UNITED STATES
NUCLEAR REGULATORY COMMISSION
WASHINGTON, D.C. 20555-0001

SUBJECT: LIMERICK GENERATING STATION, UNITS 1 AND 2 - STAFF ASSESSMENT OF INFORMATION PROVIDED PURSUANT TO TITLE 10 OF THE *CODE OF FEDERAL REGULATIONS* PART 50, SECTION 50.54(f), SEISMIC HAZARD REEVALUATIONS FOR RECOMMENDATION 2.1 OF THE NEAR-TERM TASK FORCE REVIEW OF INSIGHTS FROM THE FUKUSHIMA DAI-ICHI ACCIDENT (TAC NOS. MF3864 AND MF3865)

STAFF ASSESSMENT BY THE OFFICE OF NUCLEAR REACTOR REGULATION
RELATED TO SEISMIC HAZARD AND SCREENING REPORT
LIMERICK GENERATING STATION, UNITS 1 AND 2
DOCKET NOS. 50-352 AND 50-353

Figure 3.3-1 Plot of NRC's and Licensee's Base Case Shear-Wave Velocity Profiles for the LGS Site

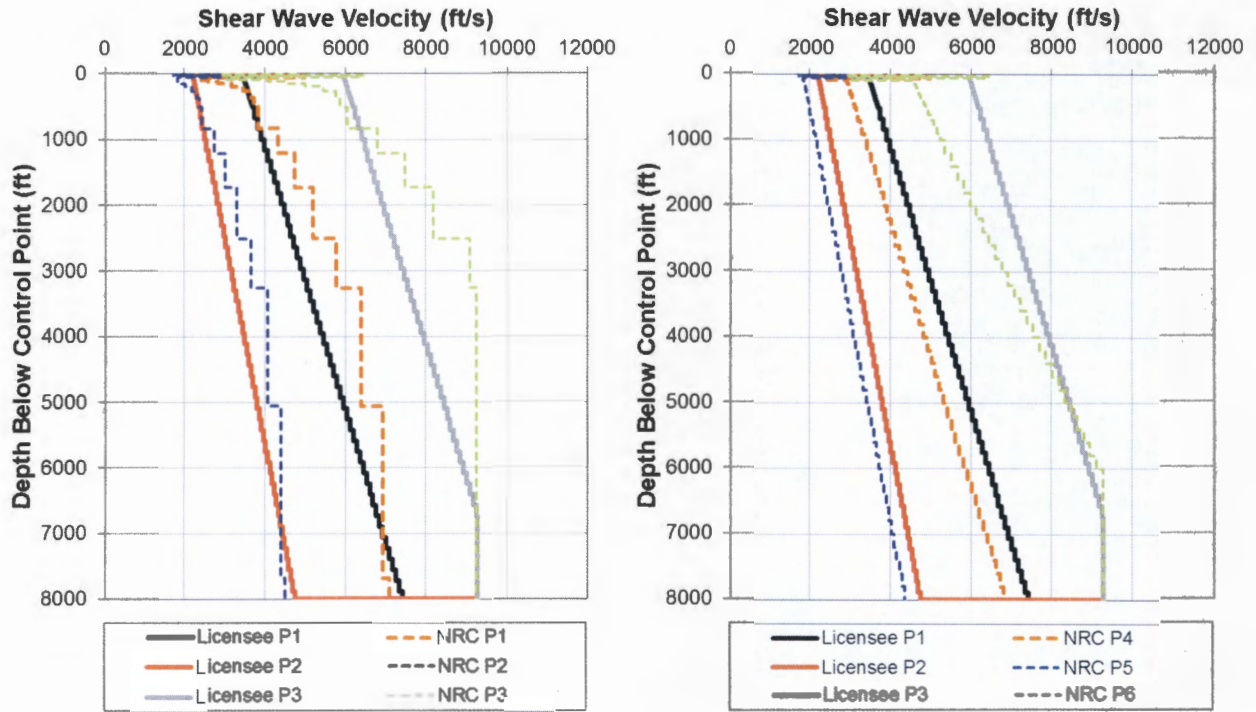
The NRC staff used the ISFSI shear wave velocity data to characterize the dynamic properties in the upper 50 ft. (15 m). The NRC staff used the SPID template velocity profiles and a constant velocity gradient (as shown in Figure 3.3-1 of this assessment), to estimate the shear wave velocity at depths greater than 50 ft. (15 m). The NRC staff used a scale factor of 1.28, corresponding to a natural log standard deviation of 0.25, to estimate lower and upper base case velocity profiles. The NRC staff velocity profiles differ moderately from those proposed by the licensee.

Figure 3.3- 1 Plot Comparing the NRC's and the Licensee's Median Amplification Functions and Uncertainties for the LGS site.

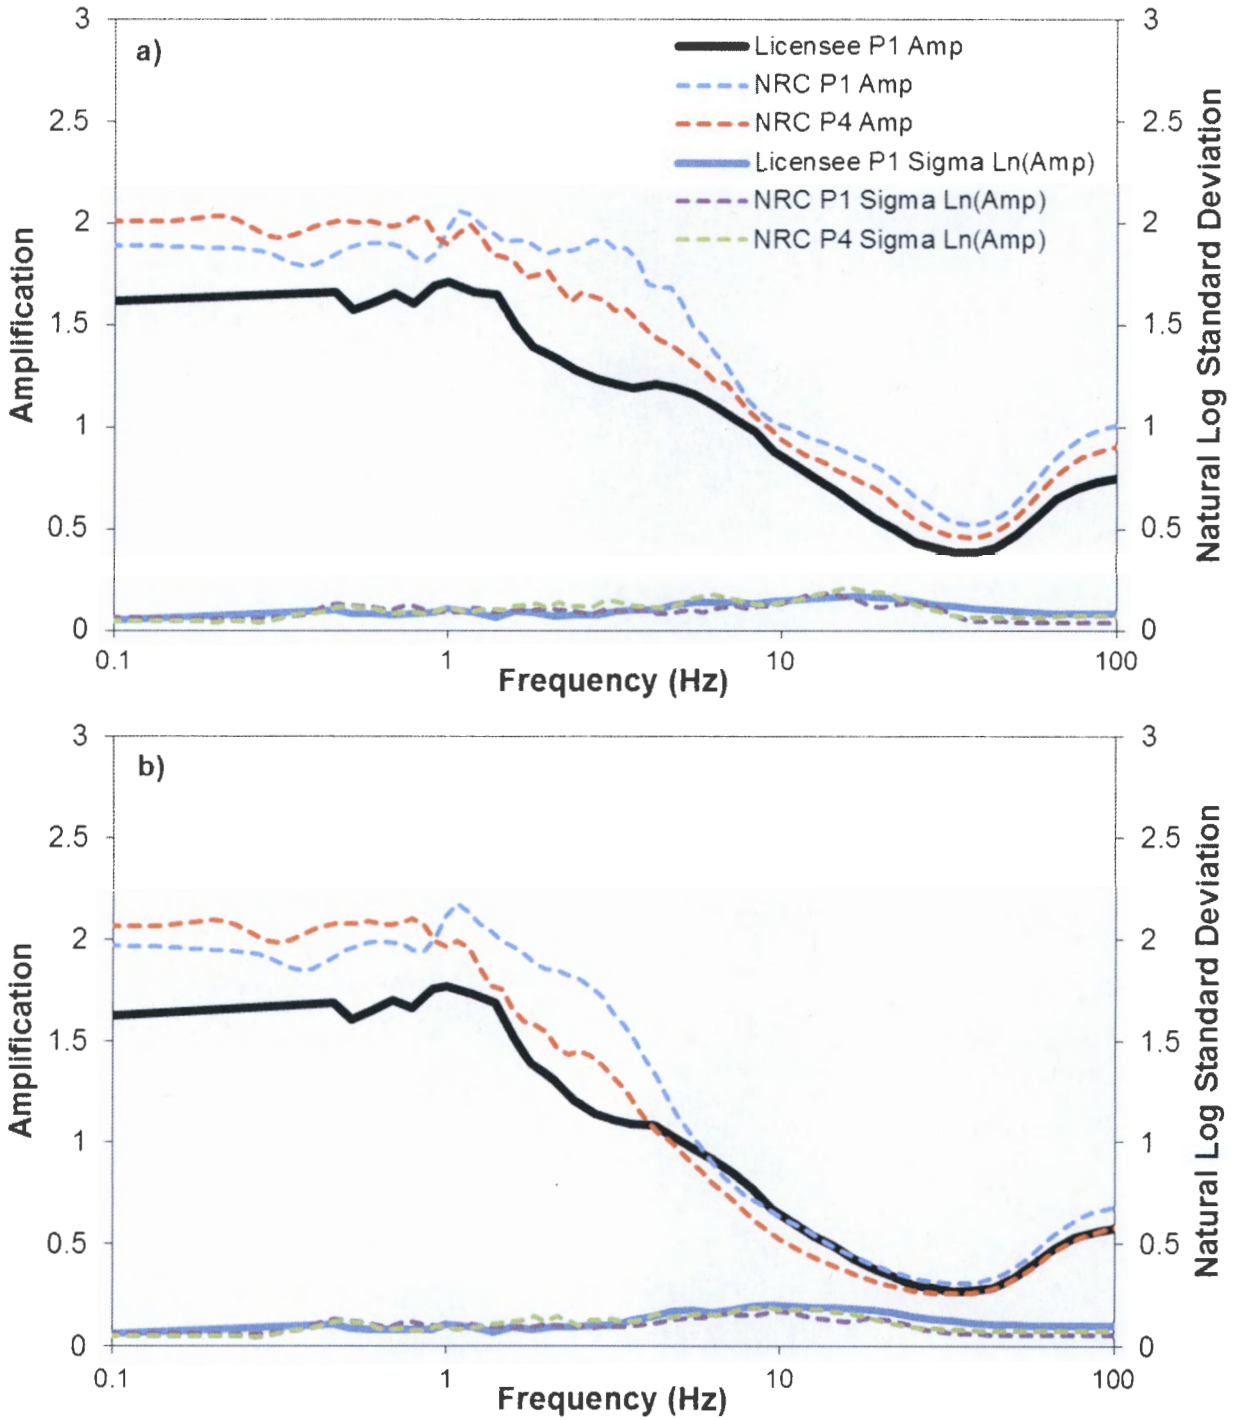
Figure 3.3-2 of this assessment shows a comparison of the NRC staff's and licensee's median site amplification functions and uncertainties for 2 of the 11 input loading levels. At low acceleration amplitudes, the amplification functions are slightly greater than the licensee amplification functions (Figure 3.3-2a). The difference between NRC and licensee amplification functions above 1 Hz reduces with larger input acceleration amplitudes. The amplification function standard deviation computed by the NRC staff and licensee are similar.

The difference between the licensee and NRC staff shear wave velocity profiles is the most significant factor leading to differences the amplification functions. The differences in amplification function lead to minor differences in the hazard curves shown in Figure 3.3-3 of this assessment. The shape of the control point hazard curves are similar. At 1 Hz, the licensee hazard curve is slightly steeper. Appendix B of the SPID provides guidance for performing site response analyses, including capturing the uncertainty for sites with less subsurface data; however, the guidance is neither entirely prescriptive nor comprehensive. As such, alternative approaches in performing site response analyses, including the modeling of uncertainty, are acceptable for this application.

Figure 3.4-1 Comparison of the NRC's GMRS with Licensee's GMRS and the SSE for the LGS site

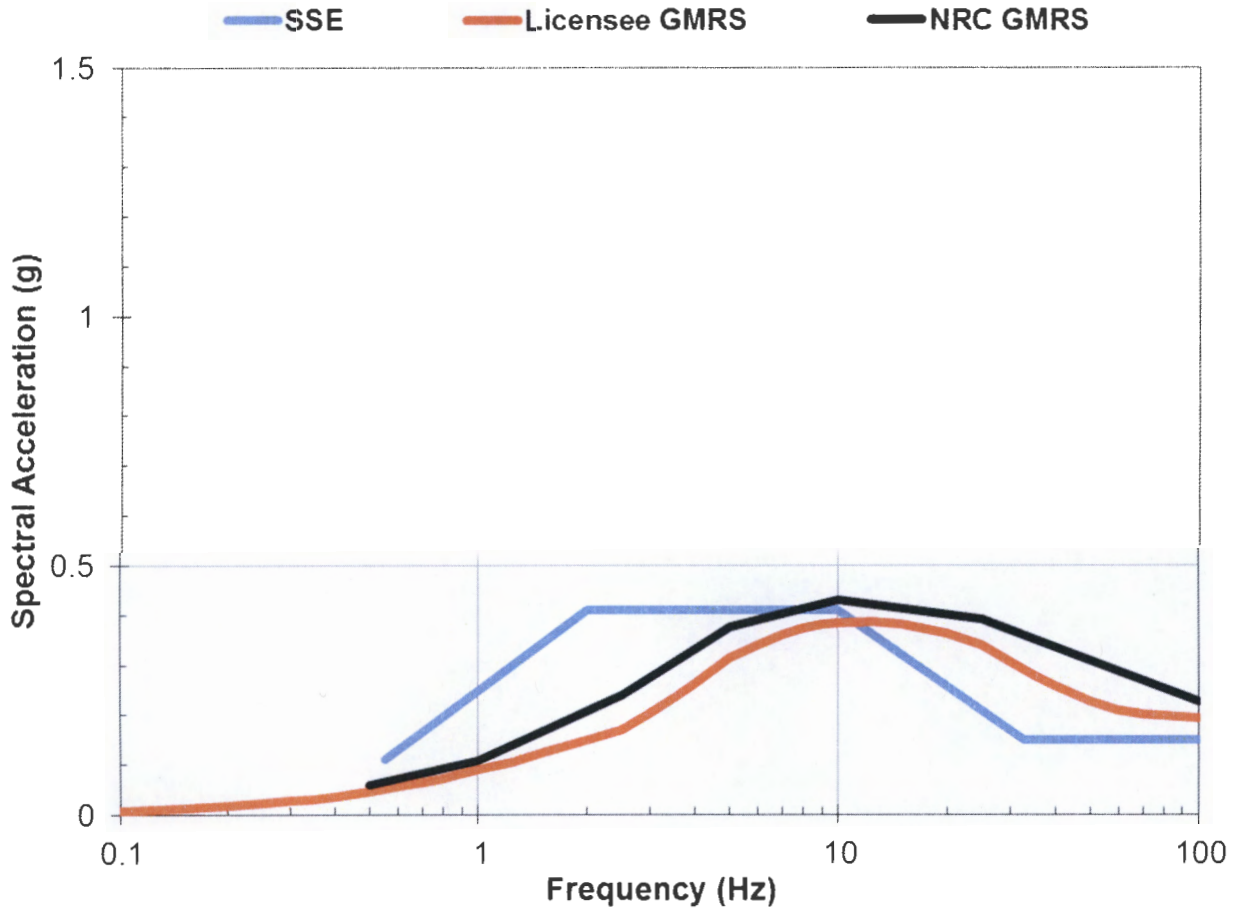
The NRC staff independently calculated the 10^{-4} and 10^{-5} UHRS using the results of its confirmatory PSHA and site response analysis, as described in Sections 3.2 and 3.3 of this staff assessment, respectively. Figure 3.4-1 of this assessment shows a comparison of the GMRS determined by the licensee to that determined by the NRC staff.

As shown in Figure 3.4-1 below, the licensee's GMRS shape is generally similar to that calculated by the NRC staff. At frequencies where the amplitude of the GMRS determined by the licensee is different from that determined by the NRC staff, the staff's GMRS generally exceeds that of the licensee. These differences in GMRS are the result of differences in the site response analyses performed by the licensee and NRC staff as discussed in Section 3.3 above.

The NRC staff confirms that the licensee used the present-day guidance and methodology outlined in RG 1.208 and the SPID to calculate the horizontal GMRS, as requested in the 50.54(f) letter. The NRC staff performed both a PSHA and site response confirmatory analysis and achieved results consistent with the licensee's horizontal GMRS. As such, the NRC staff concludes that the GMRS determined by the licensee adequately characterizes the reevaluated hazard for the LGS site. Therefore, this GMRS is suitable for use in subsequent evaluations and confirmations, as needed, for the licensee's response to the 50.54(f) letter.
